### BGA HAVE MODIFIED AND IMPROVED THE LP0802K TO OVERCOME MOVEMENT ISSUES.

## OIL PUMP MOVEMENT ISSUE

Opel/Vauxhall Y17DT; Y17DTL; Z17DTH; Z17DTL; Z17DTJ Engines.

Diagram 1

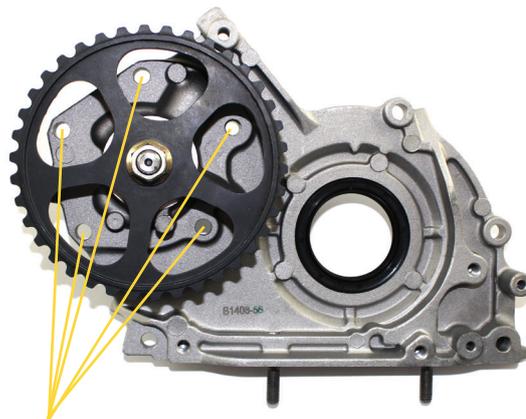
- During Timing Belt replacement, thoroughly examine the Oil Pump's rotor shaft, rotor drive contact face and behind the drive pulley for wear. If evident, replace all
- Never replace an Oil Pump without a new Pulley and locking nut
- Do not tighten beyond 25nm or 18.5 ft-lbf
- Removing the Pulley is not required during installation of the BGA Pump because it could damage the rotor seal (*Diagram 1*)
- Apply adhesive sealing compound as shown by the dotted area in *Diagram 2*

The bolt holes are accessible; Pulley removal is not necessary.

Diagram 3

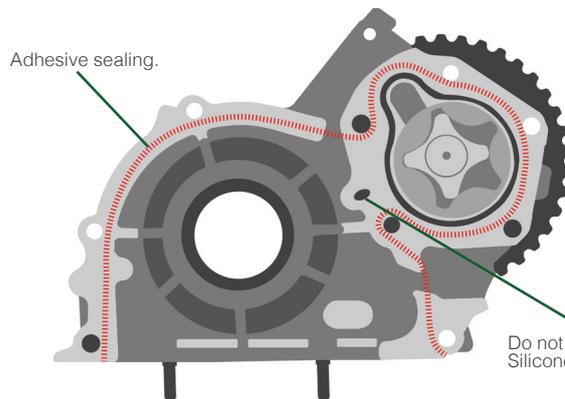
Movement between the Shaft and Pulley's contact faces due to insufficient tightening of the securing nut can affect the Oil Pump longevity. The nut will become loose and not re-tighten resulting in timing or lubrication failure. The OE equivalent has  $3 > 5^\circ$  of movement.

The rotor and Drive Pulley contact areas have been increased by 72% which reduces the movement tolerance to  $0.5 > 1^\circ$ . The Pulley has been secured and correctly torqued negating the need for removal during installation. (*Diagram 3*)
